ADDENDUM NUMBER 1

DATE: April 25, 2018

Rochester
Schools
Modernization
Program -Phase
2c
George M.
Forbes-
Renovation,
Alterations and
Addition

TYPICAL DEMOLITION DETAILS AND ELEVATIONS

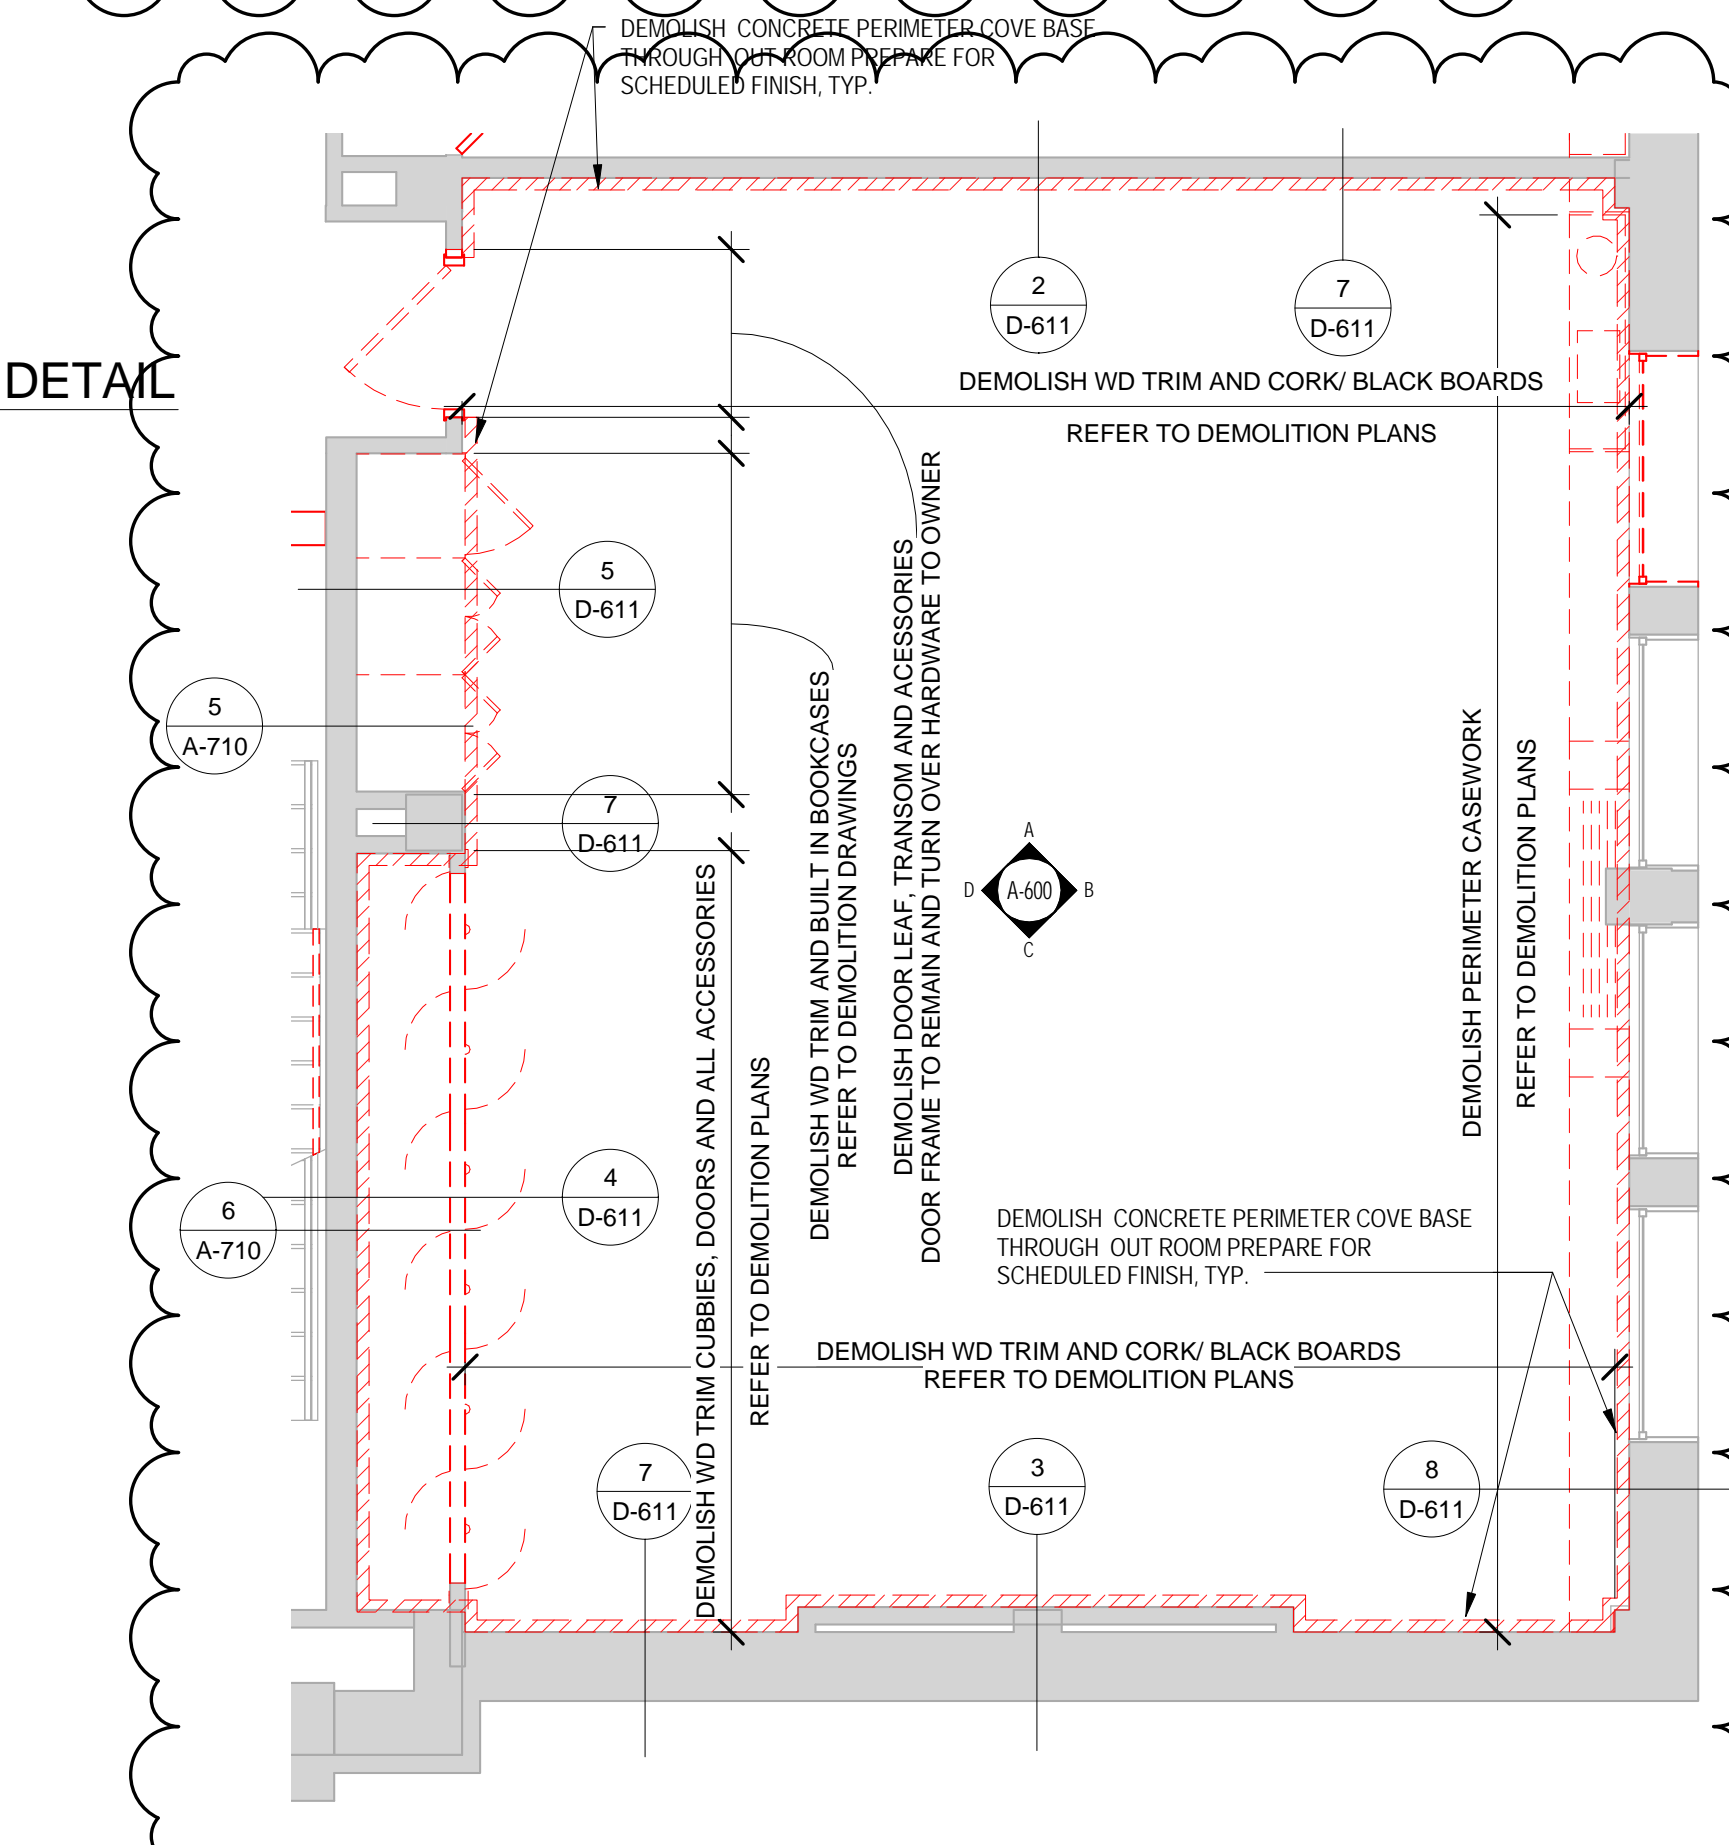
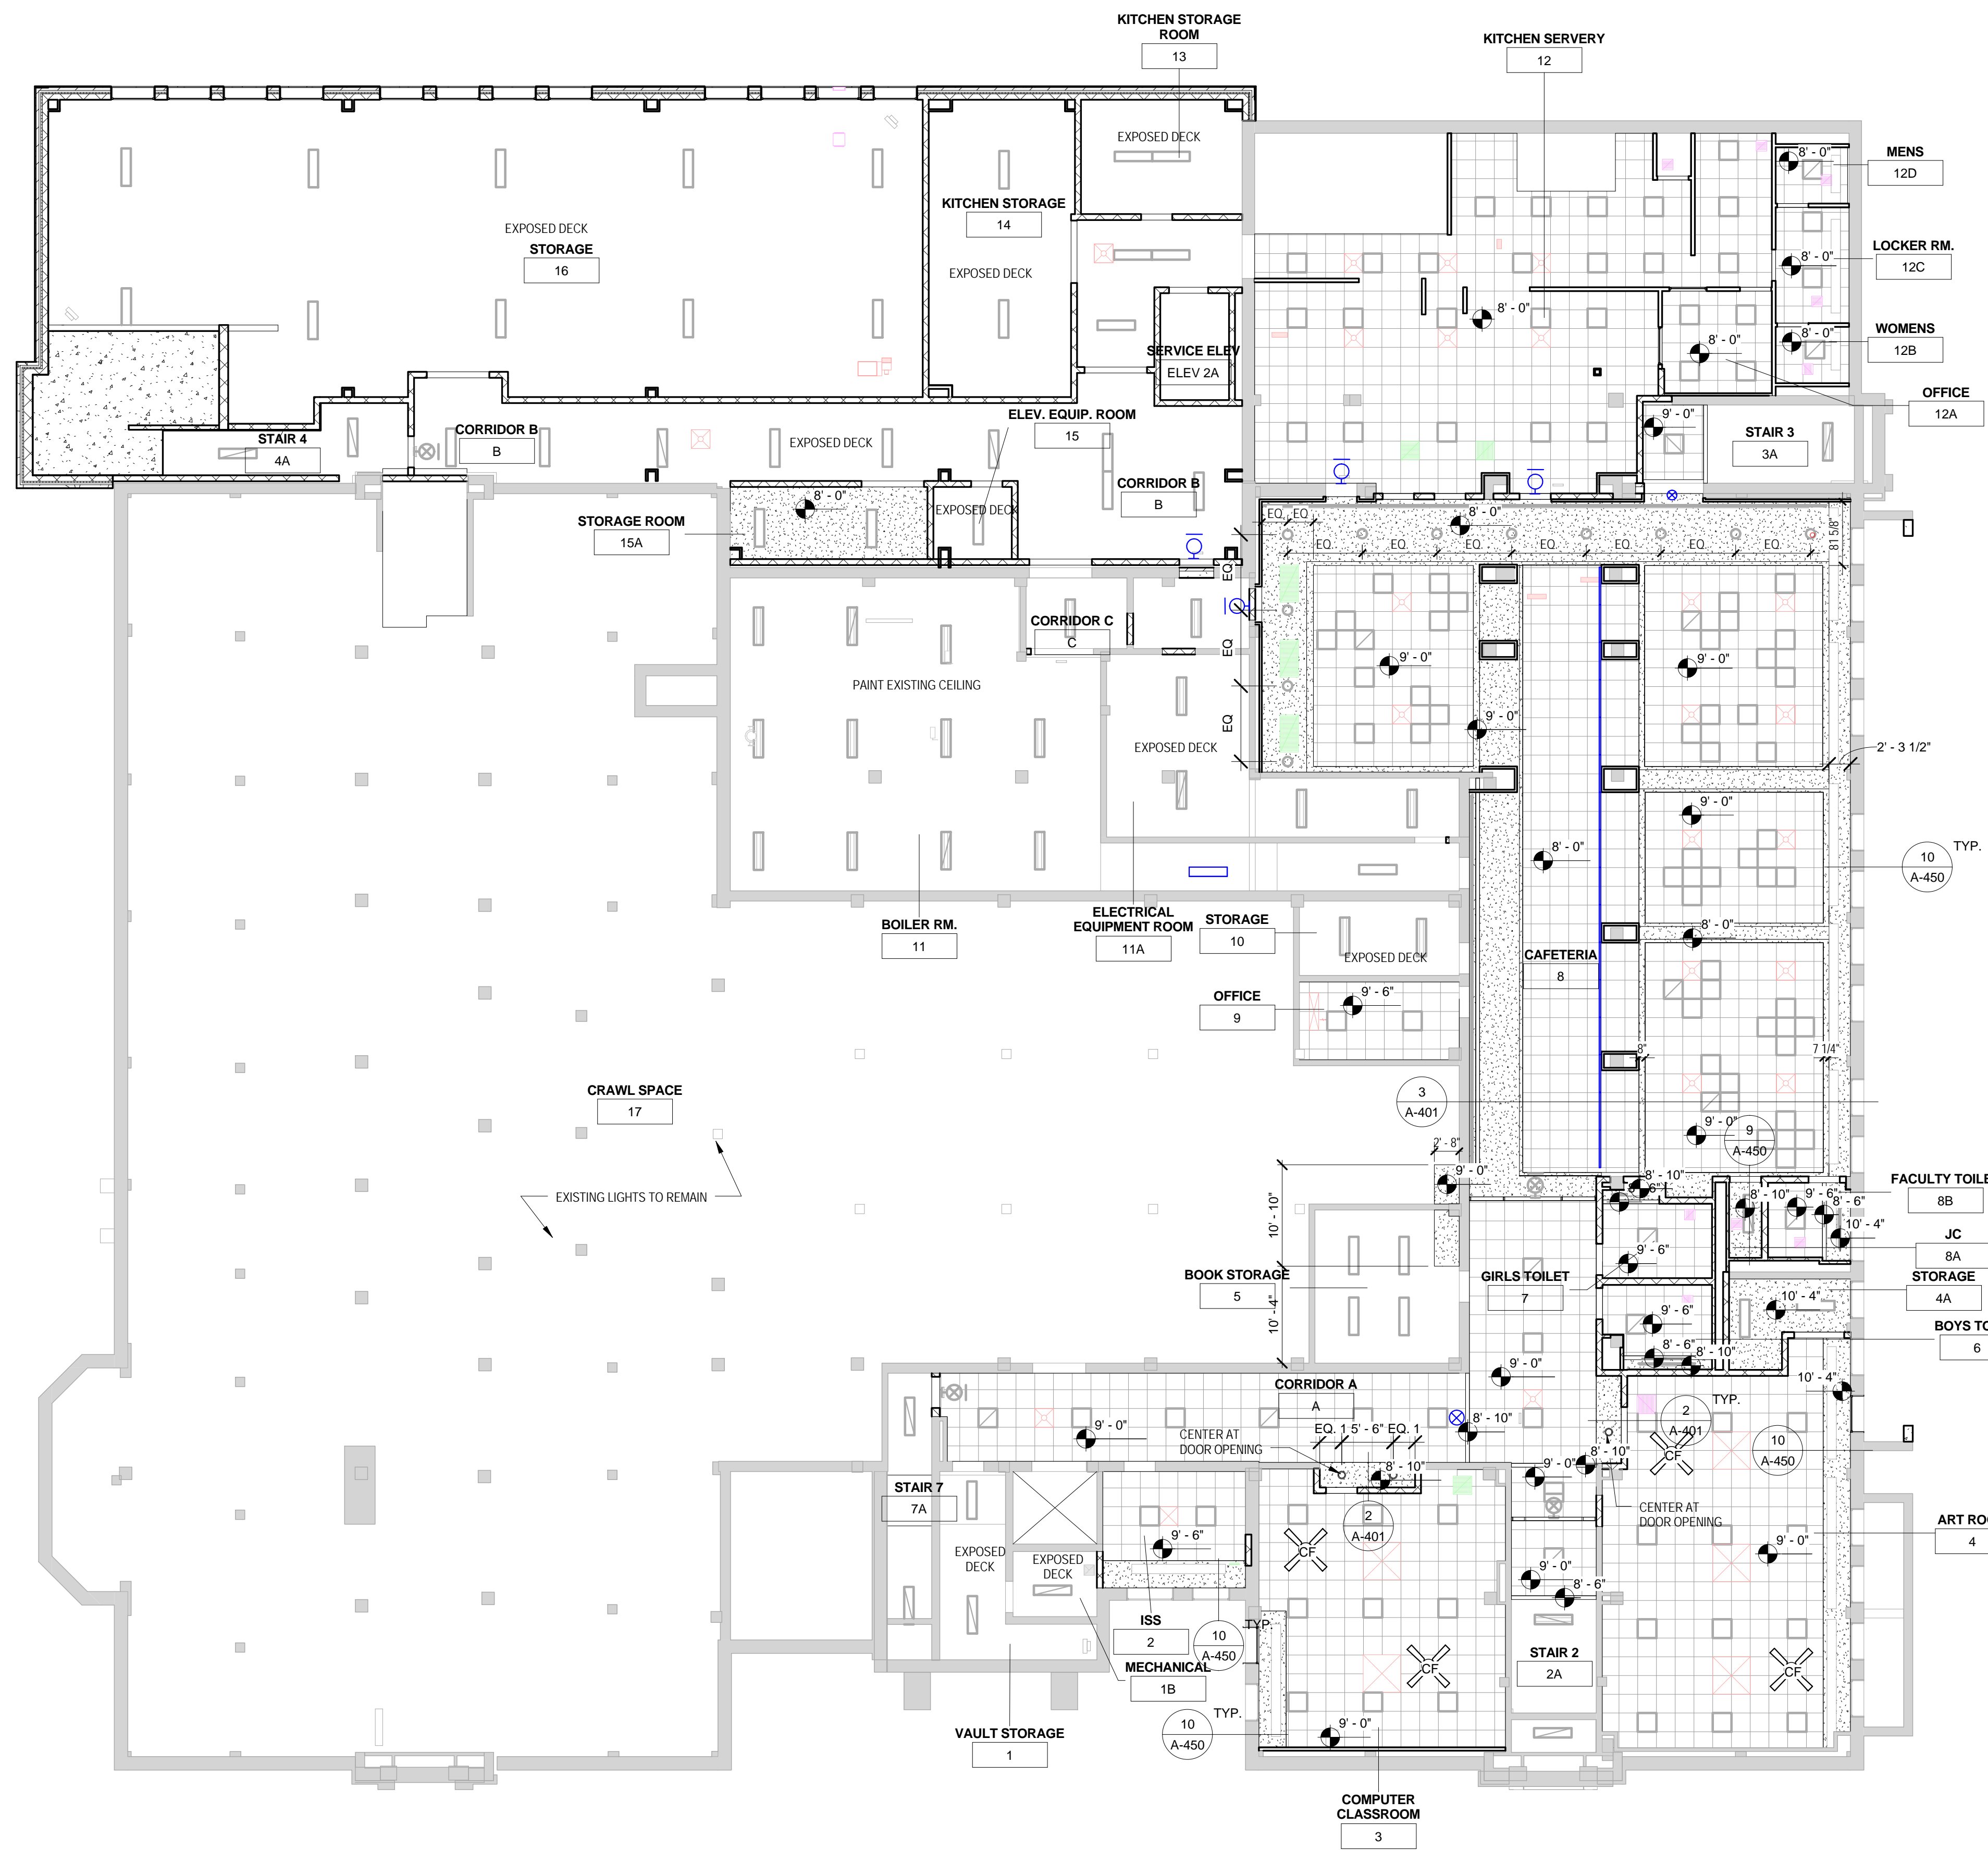
- a. Add keynote: 'W13' "REMOVE EXISTING COVE BASE AT EXISTING WALLS TO REMAIN. REFER TO D611 FOR MORE INFORMATION." To the following rooms:
CAFETERIA RM RM 35
